**BEST STREAM AND WETLAND RESTORATION PROJECT
MONITORING REPORT
MONITORING YEAR 6
FINAL**

DUPLIN COUNTY, NORTH CAROLINA
CONTRACT No. 004631 - PROJECT No. 95353
USACE Action ID No. 2012-01384 -NCDWR Project No. 13-0865

RE: Best Stream and Wetland Restoration Site: MY6 Monitoring Report (NCDMS ID 95353)

Listed below are comments provided by DMS on December 14, 2020 regarding the Best Stream and Wetland Restoration Site: Year 6 Monitoring Report and RES' responses.

Figure 3b
Best Stream and Wetland Restoration Project
Current Conditions
Plan View
MY6 2020

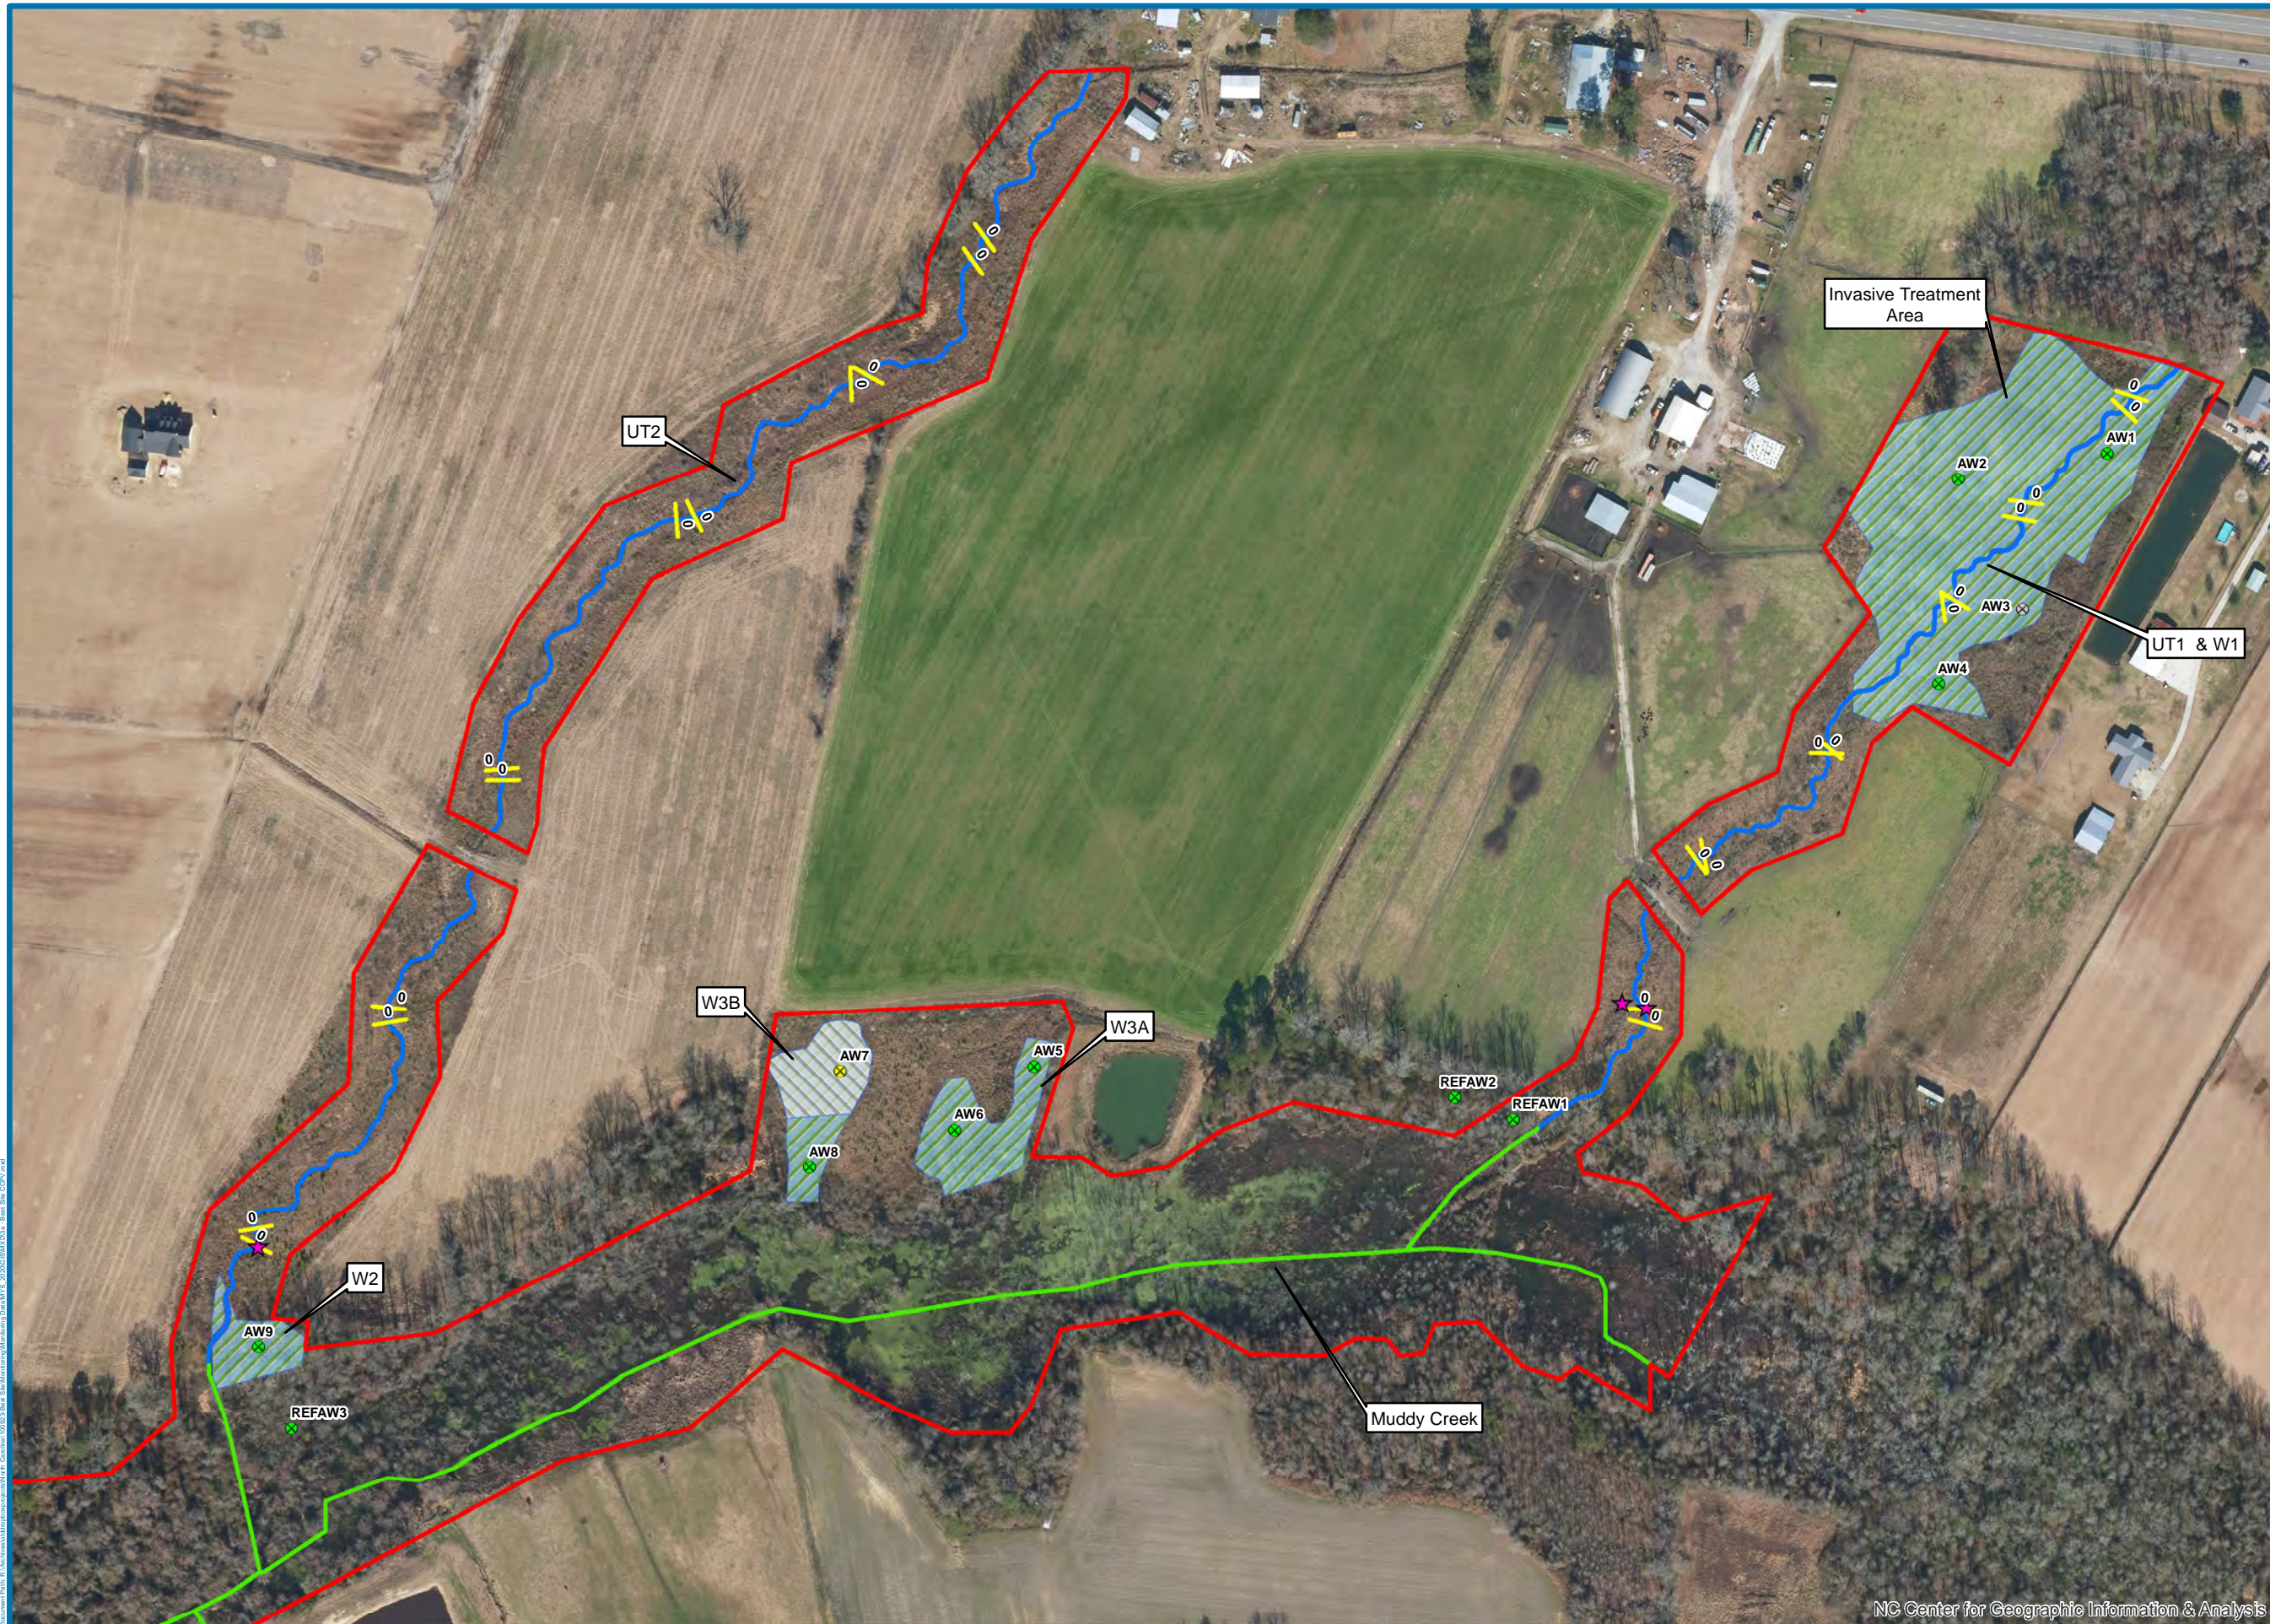
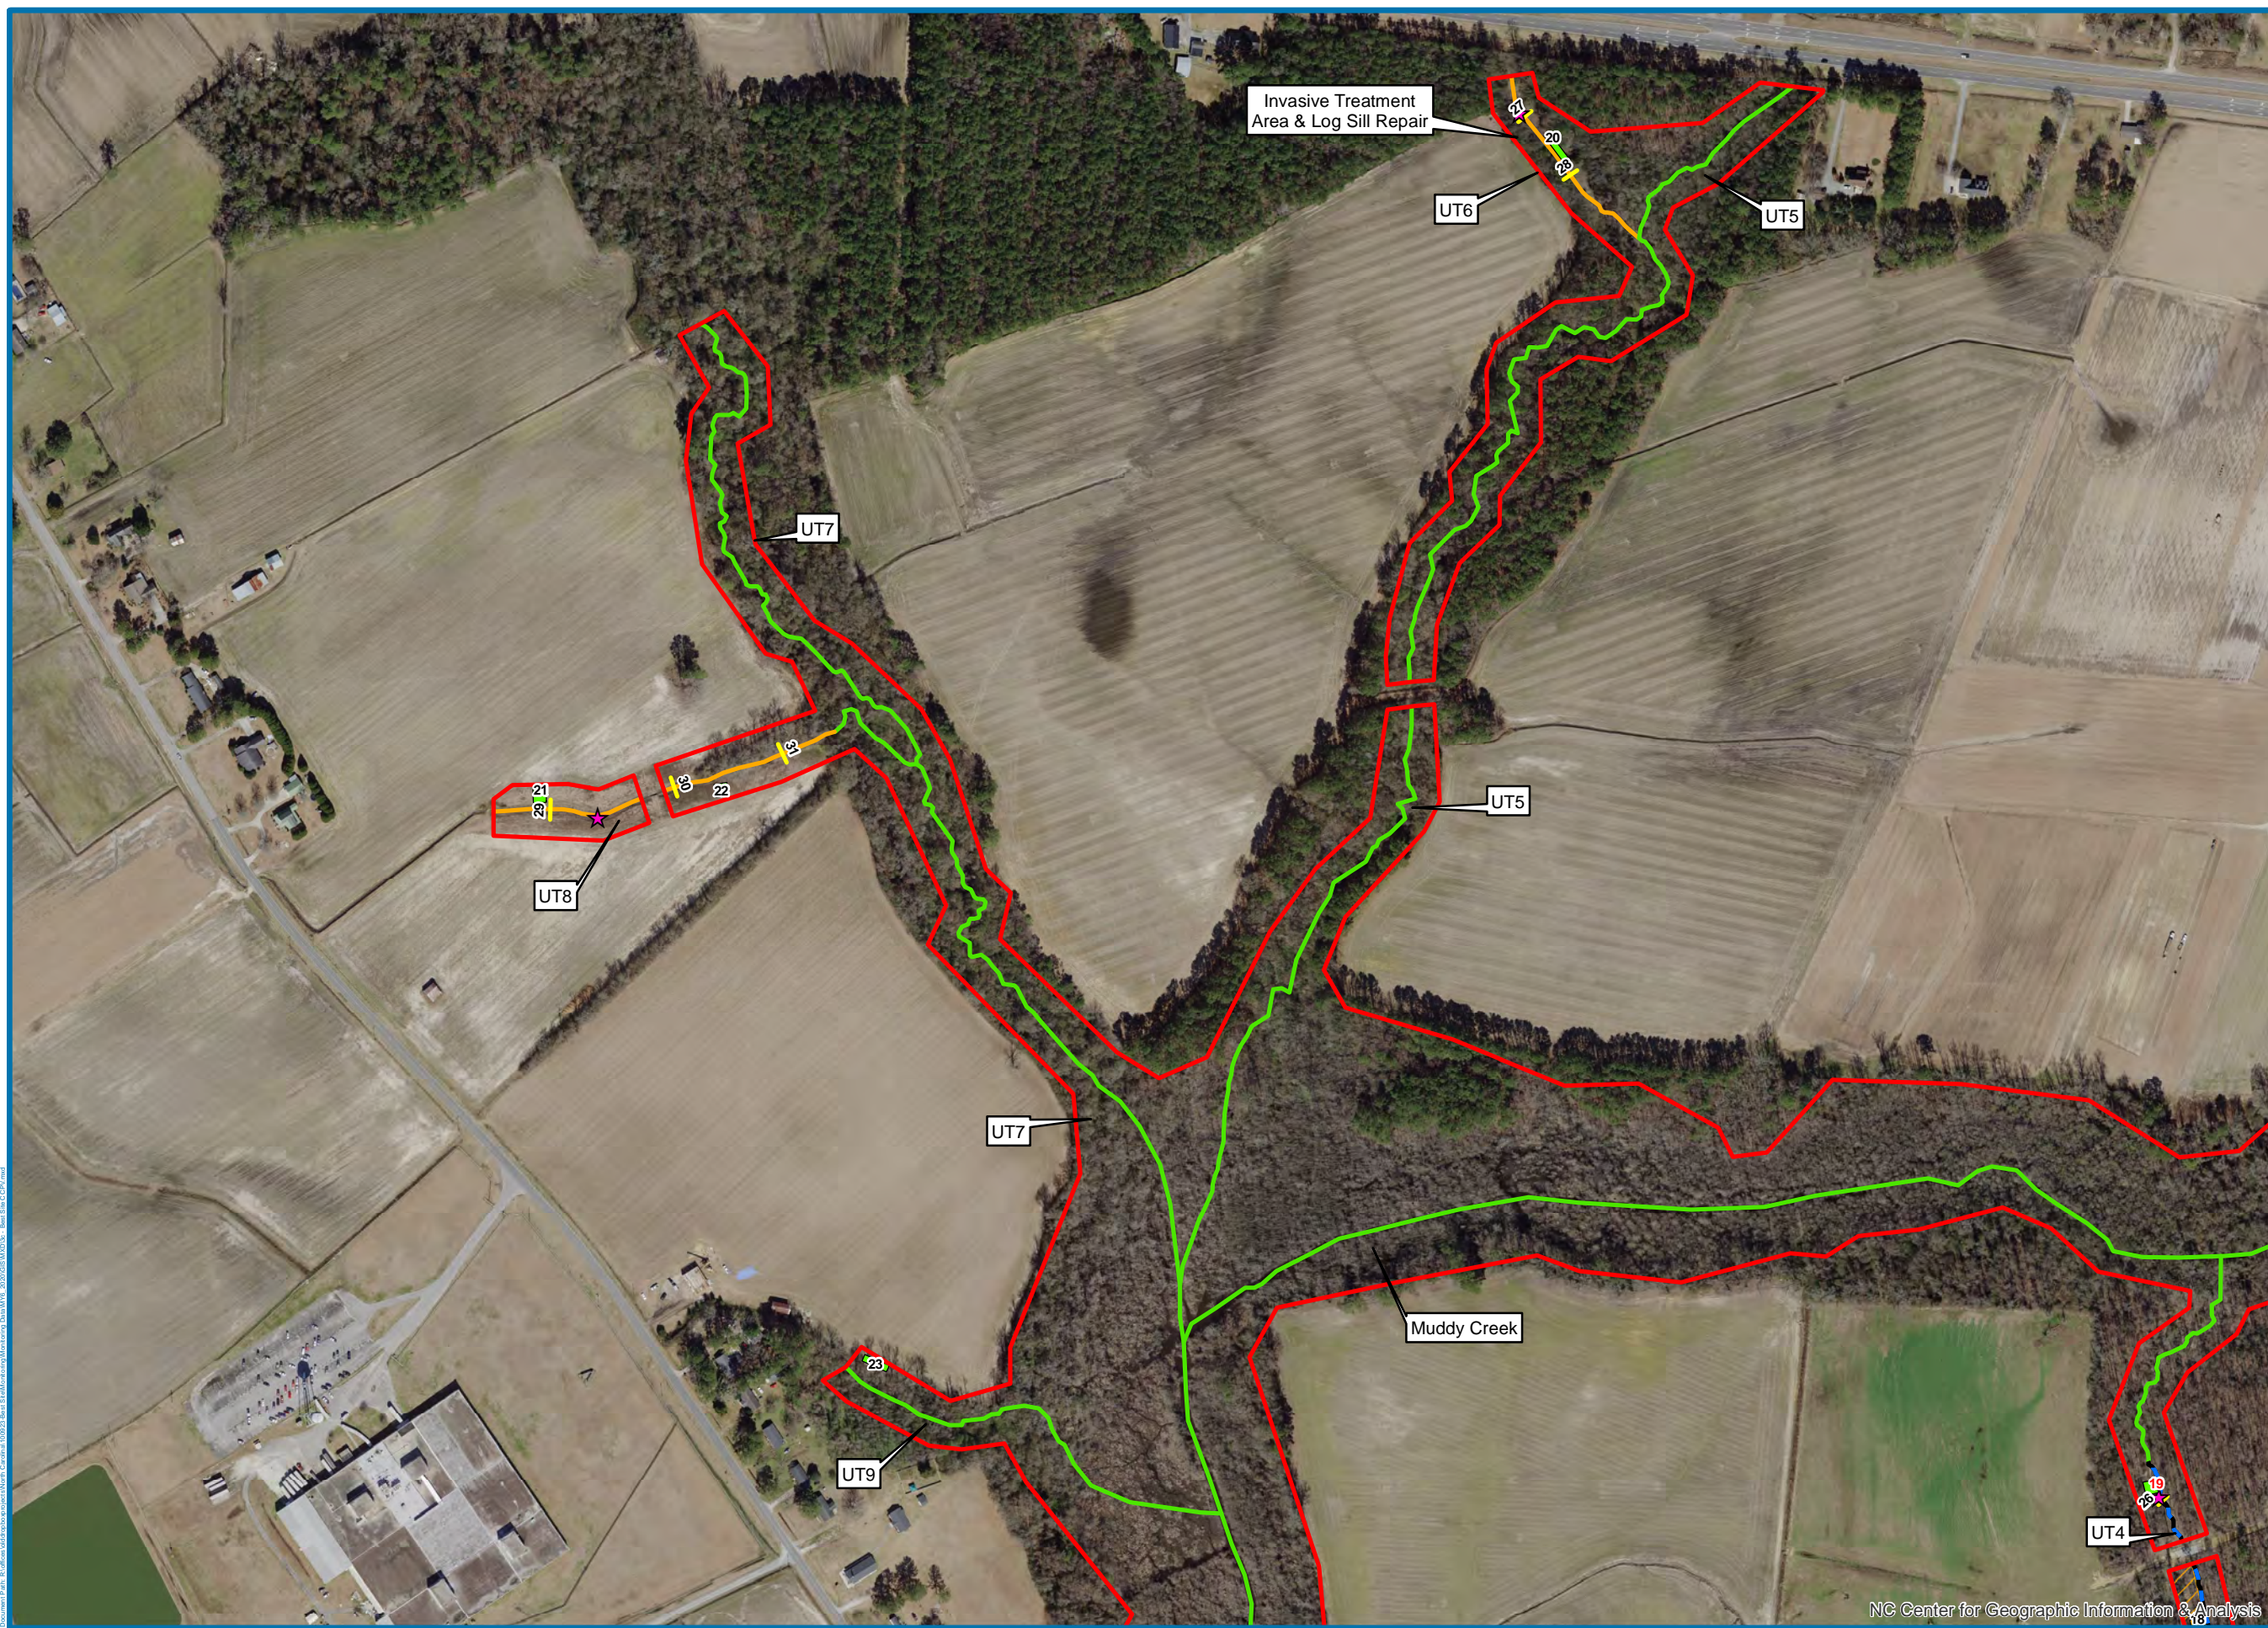
a. Please show a polygon on the CCPV for the 0.39 acres of wetland credit at risk.

b. Please show gauge ACG4 on the CCPV.

[Done.](#)

[The symbol for ACG4 was hidden behind the XS26 label. This error has been corrected.](#)

2020 Best Groundwater Gauge AW7

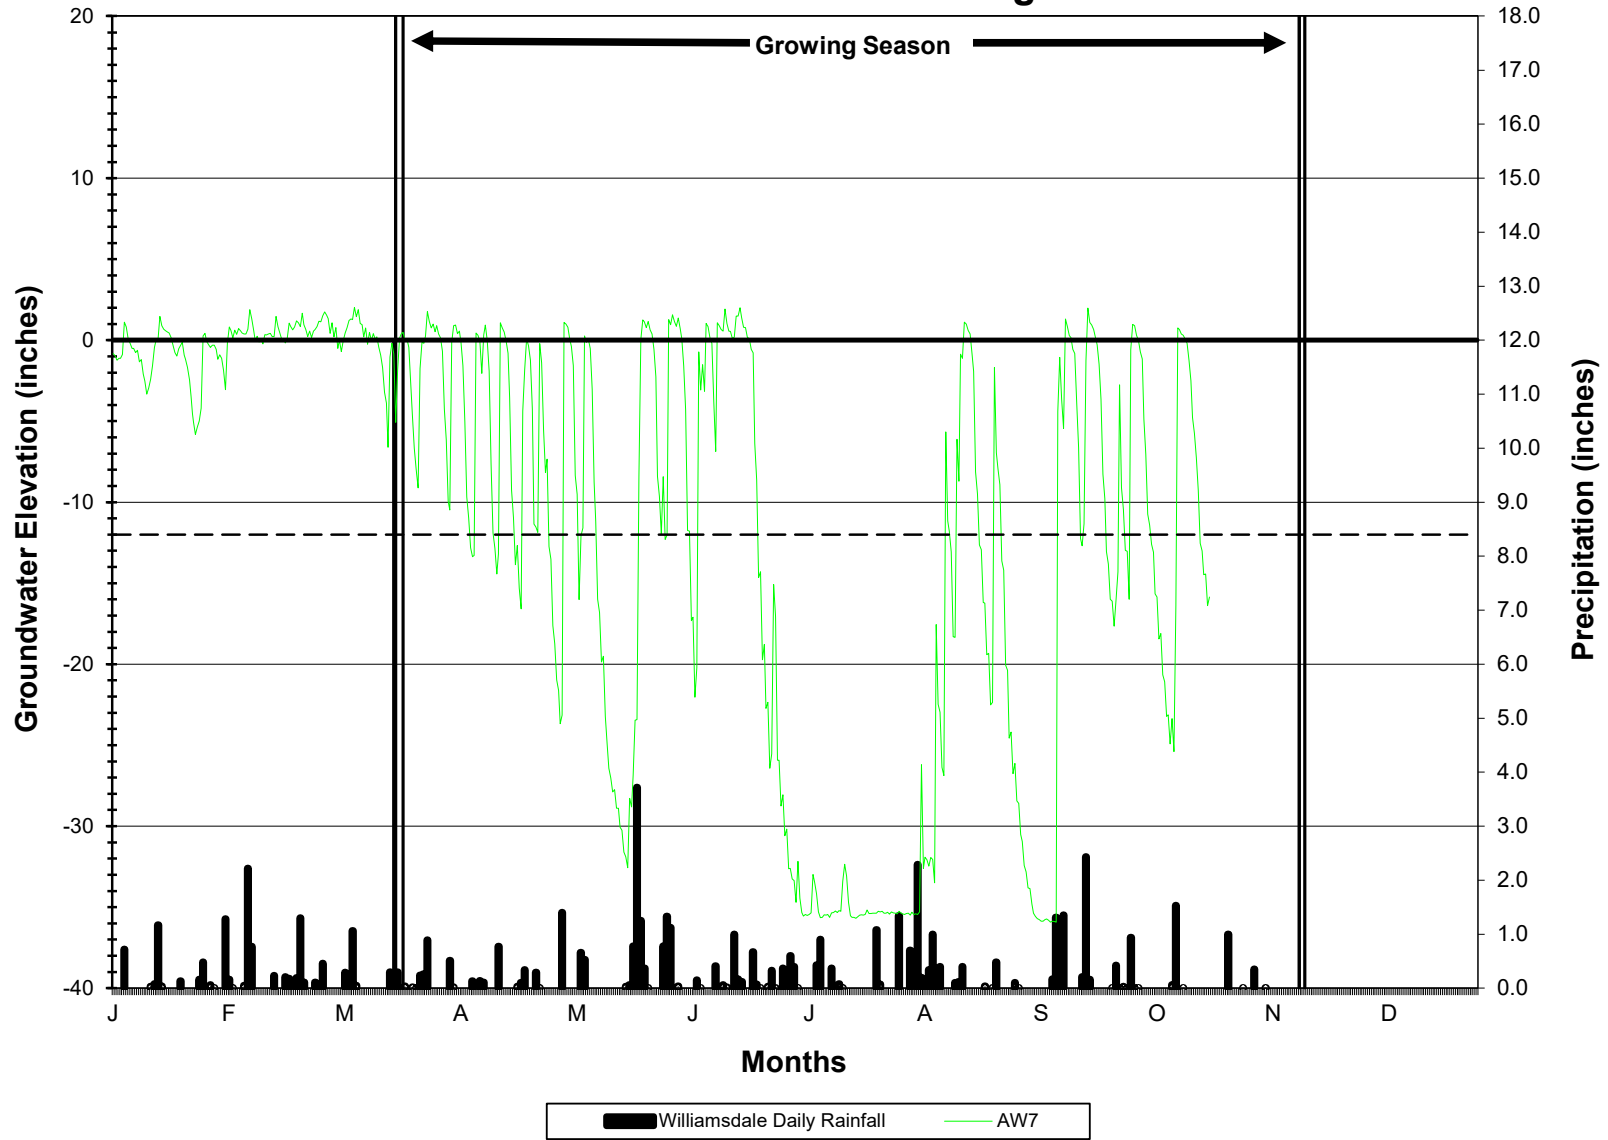
1. Section 5.1.5: a. When discussing AW7 and possible loss of wetland credit, please edit language to say that the credit loss area could be up to 0.39 acres and that RES will perform a wetland delineation and investigation of soil development (since the area may delineate as a jurisdictional wetland) to further refine the exact extent of the area that may potentially be removed from credit if the gauge fails to meet success criteria in MY7.

[Done.](#)
